53132A-07

S E R V I C E N O T E

53132A 225 MHz Counter

Serial Numbers: MY47000000 to MY47001807
SG47000000 to SG47000268

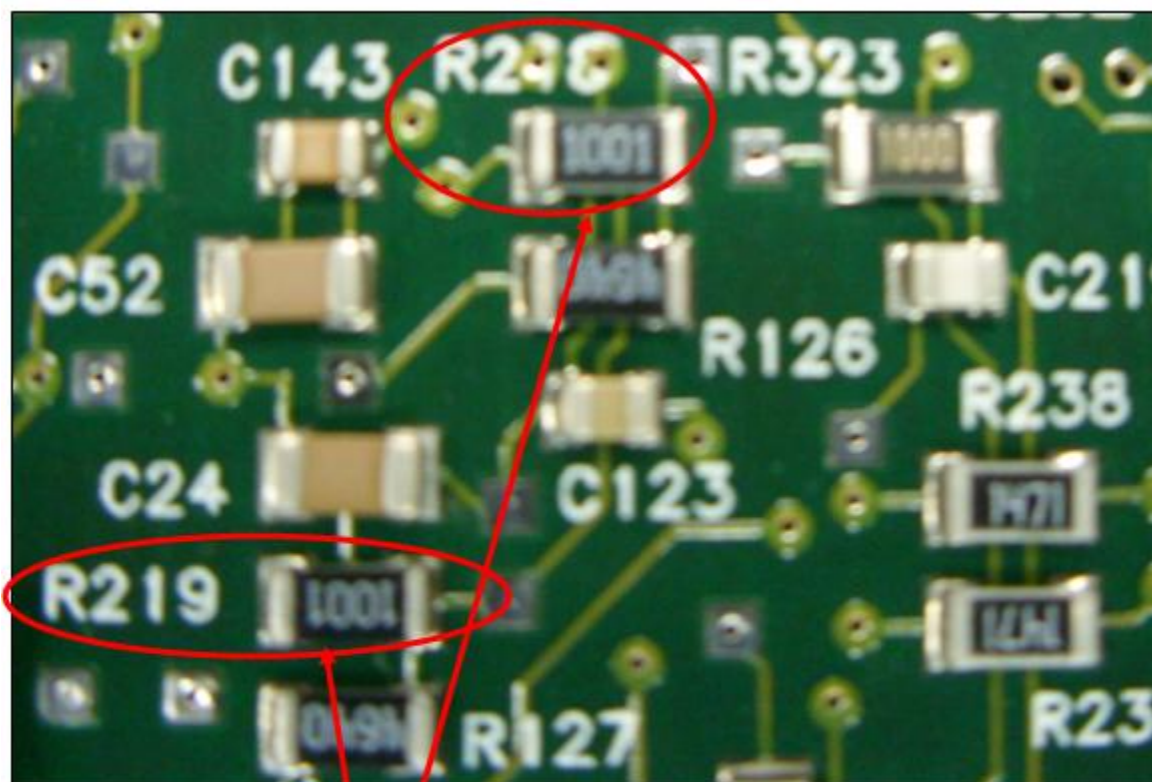
Incorrect triggering can occur if both channels have been configured for a measurement since the last power cycle or if large signals (> 10 Vpp) are used. The counter may use the trigger from one channel to initiate a measurement on the other channel.

Replace resistor 0699-1318 at reference designators R219 and R218 with 0699-1377 (2.37 KOhm).
